ZONING MAP

WINDY HILL PROFESSIONAL OFFICE BUILDING

PETITION NO: Z-5

Z-5 DAVID TASH

Z-5

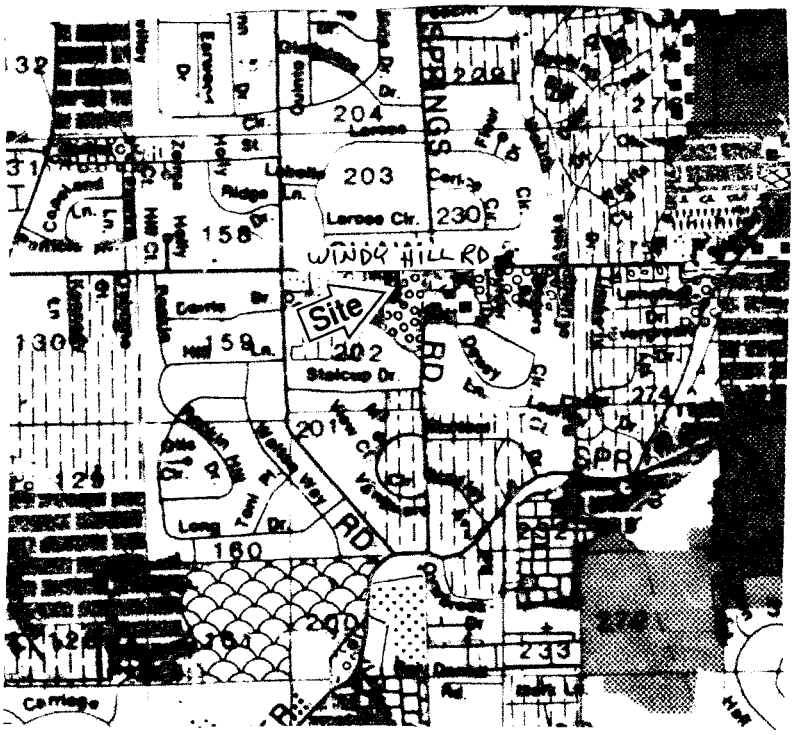
The applicant is showing a contemporaneous variance which is to reduce the side setback adjacent to the east property line from 15-feet to 10-feet.

1. The existing site discharges to the west through the adjacent Piedmont Villas Apartments. There is not adequate stormwater conveyance to accommodate a concentrated discharge from the proposed site through this older apartment complex. The proposed underground detention system must be designed to discharge directly to the existing stormwater system located within the Windy Hill Road R/W.
2. Since a portion of the adjacent St. Jude Episcopal Church property drains through the proposed site, this runoff must be accommodated in the site stormwater design and adequate conveyance provided though the site.

Windy Hill Road is classified as an Arterial and according to the available information, the existing right-of-way does not meet the minimum requirements for this classification.

Recommend applicant consider entering into a development agreement pursuant of O.C.G.A. 36-71-13 for dedication of the following system improvements to mitigate traffic concerns: a) donation of right-of-way on the south side of Windy Hill Road, a minimum of 50' from the roadway centerline.

Based on the above analysis, Staff recommends DELETION to LRO subject to the following conditions:

- Site plan received by the Zoning Division December 6, 2007, with the District Commissioner approving minor modifications;
- Fire Department comments;
- Water and Sewer comments and recommendations;
- Stormwater Management comments and recommendations;
- DOT comments and recommendations; and
- owner/developer to enter into a Development Agreement pursuant to O.C.G.A. §36-71-13 for dedication of system improvements to mitigate traffic concerns.
